MILLSTONE NUCLEAR POWER STATION UNIT NO. 1

AMENDMENT TO PROVISIONAL OPERATING LICENSE

Amendment No. 33
License No. DPR-21

MILLSTONE NUCLEAR POWER STATION UNIT NO. 2

FIGURE 6.2-1

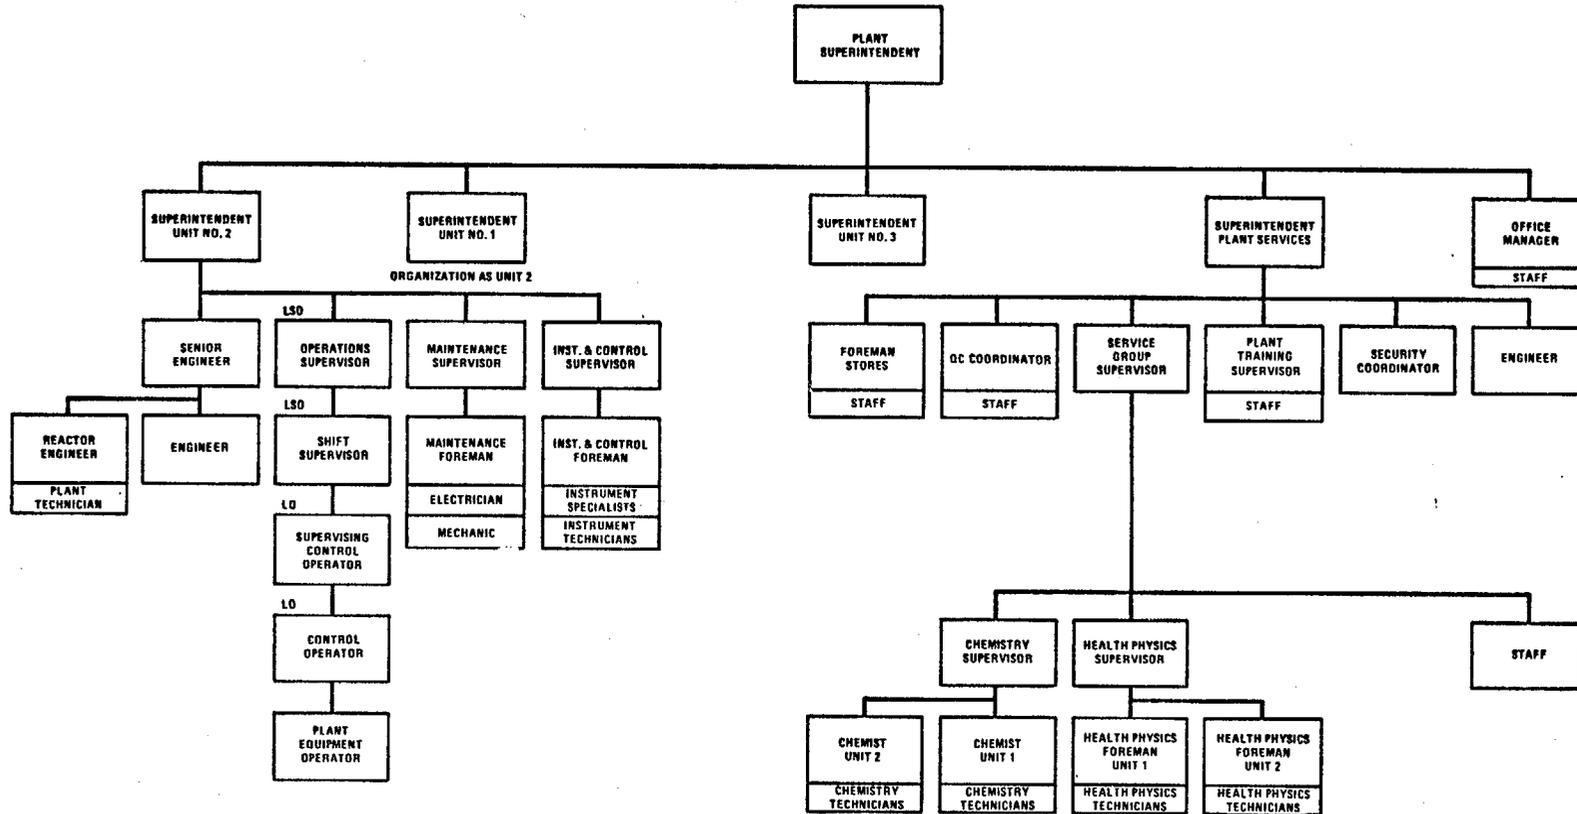
NNECO has proposed two changes to the offsite organizational structure contained in Millstone Units Nos. 1 and 2 Technical Specification 6.2.1. The first change involves the title "V. P. System Operations" which is being changed to "V. P. System Production." The second change involves a modification to the reporting level for the Nuclear Review Board (NRB) which reported directly to the President of NNECO. The proposed reporting level for the NRB is the Vice President of NNECO who in turn reports to the President of NNECO.

The proposed modifications to the offsite organization are acceptable since they in no way degrade the managerial, technical support, or review and audit functions of the offsite organization.
